**From:** Raji Tripathi  
**To:** WND2.WNP4.DBM  
**Date:** 4/2/98 11:01am  
**Subject:** CRGR ENDORSEMENT

On March 13, 1998, at the CRGR Meeting No. 317, the Committee reviewed the draft Reg. Guide DG-1069, "Fire Protection Program for Nuclear Power Plants During permanent Shutdown and Decommissioning." The Committee made various comments and recommended that resolution of one particular comment regarding applicability of 10 CFR Part 100, be submitted to the CRGR staff for review. The Committee did not wish to review the revised text.

**DRAFT REGULATORY GUIDE DG-1069**

**FIRE PROTECTION PROGRAM  
FOR NUCLEAR POWER PLANTS DURING  
DECOMMISSIONING AND PERMANENT SHUTDOWN**

*Figure 1: Side View of a Model 660 Series Projector*

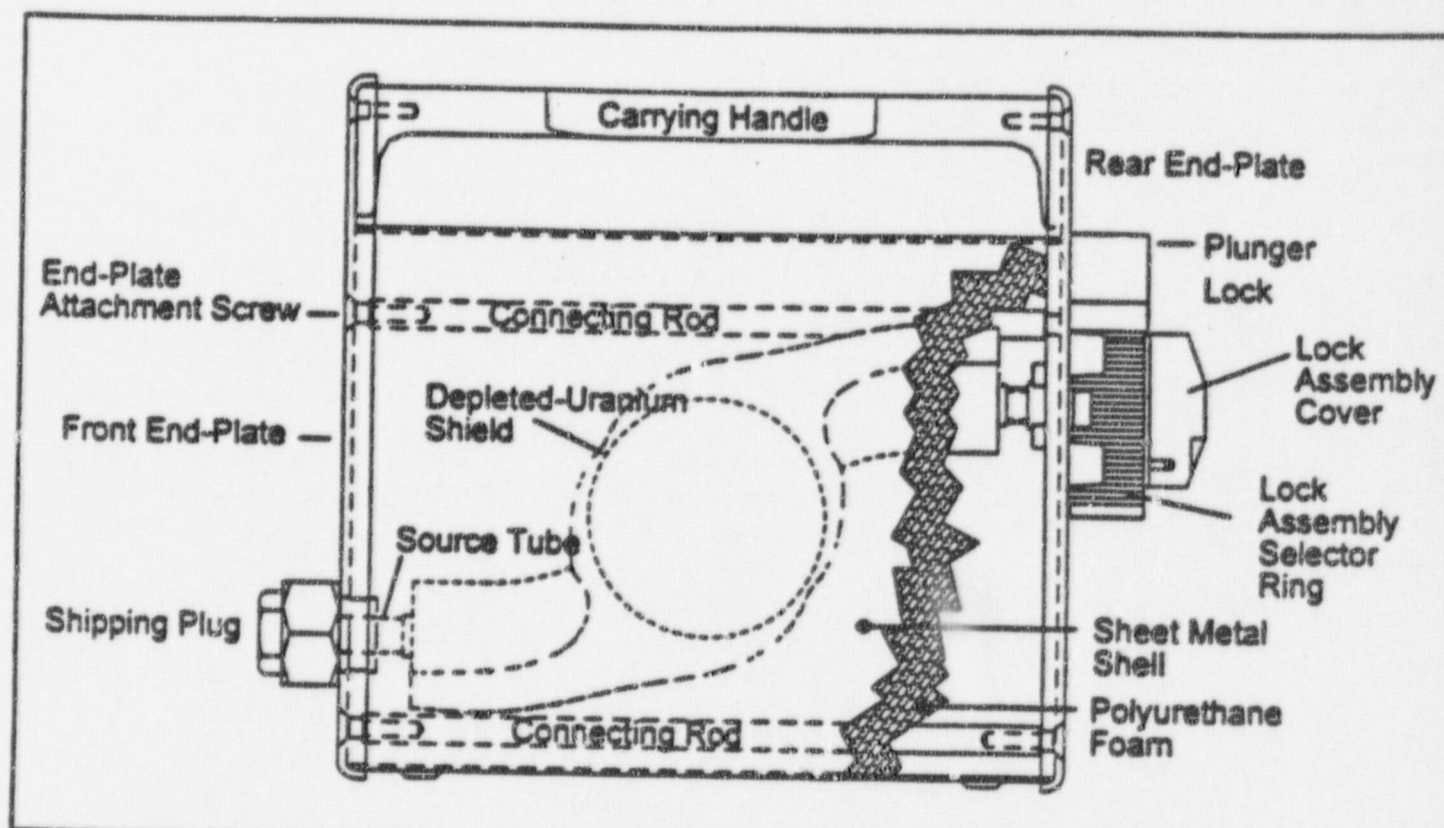
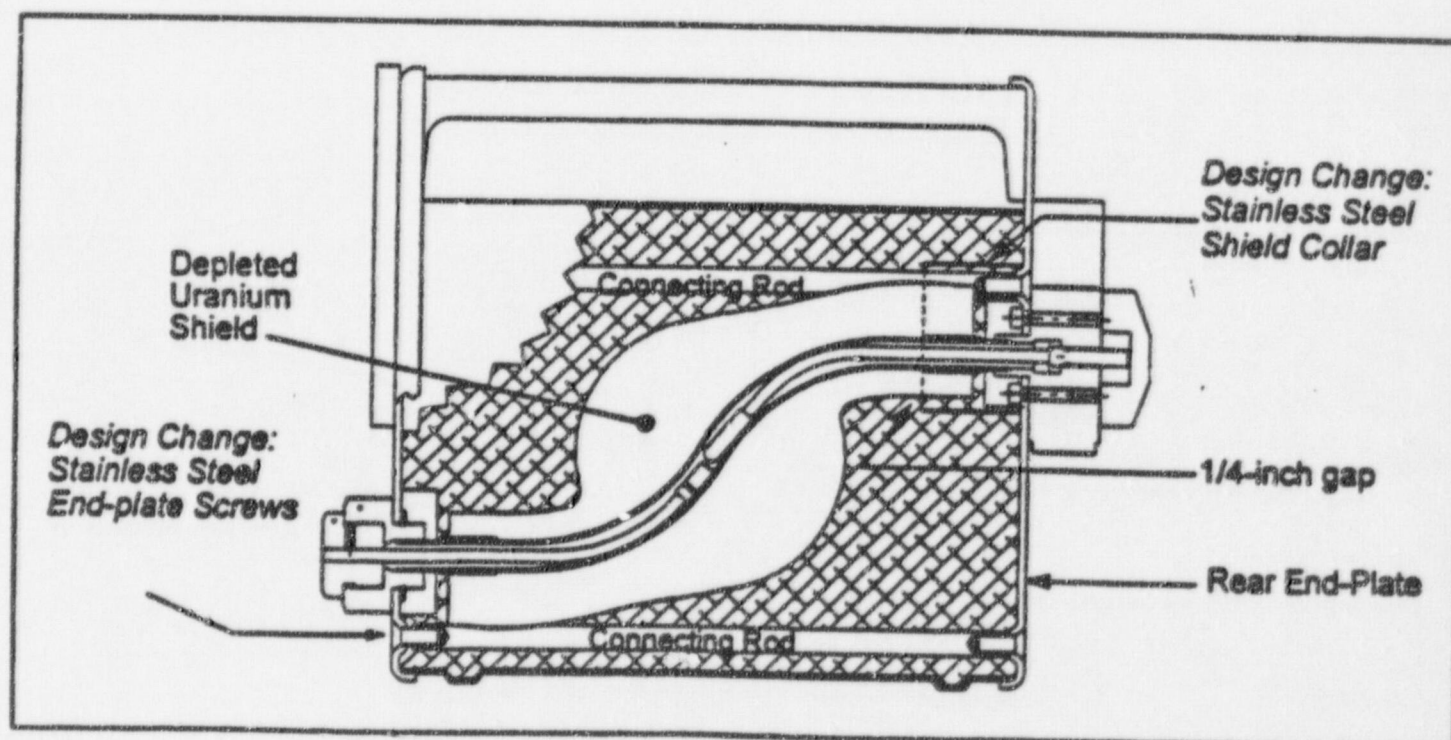
### Results of testing unmodified packages

First design modification

- replace carbon steel bolts with stainless steel bolts.

Second design modification

- added shield collar.

C. Haughney (NMSS) briefed the CRGR seeking Committee's advice on proposed modifications to address design deficiencies in the Amersham Model 660 Radiography Camera. The staff's presentation material is included as Attachment 3. The specific concerns were those related to the possible failure of Amersham Model No. 660 radiography camera to satisfy the 30-foot drop, 40-inch puncture onto steel pin<sup>1</sup>, and 30-minutes fire tests. At the time of CRGR briefing, Amersham had been conducting these tests and considering possible design modifications for incorporating them in the future production. In particular, two specific design modifications were under consideration. One of them was replacement of the carbon steel bolts with stainless steel bolts, and the other one was inclusion of an added shield collar. The Committee offered various comments. However, since this meeting, the Committee has been informed that the prototypes Model 660 camera with the latter modification had failed the drop test and, as a result, Amersham has decided to use over-pack instead.

- a. Allow shield collar to be used on existing packages, as a substitute for shipping within a steel drum or box.
- b. Not allow shield collar for new units. A more positive design change should be used for future fabrication.
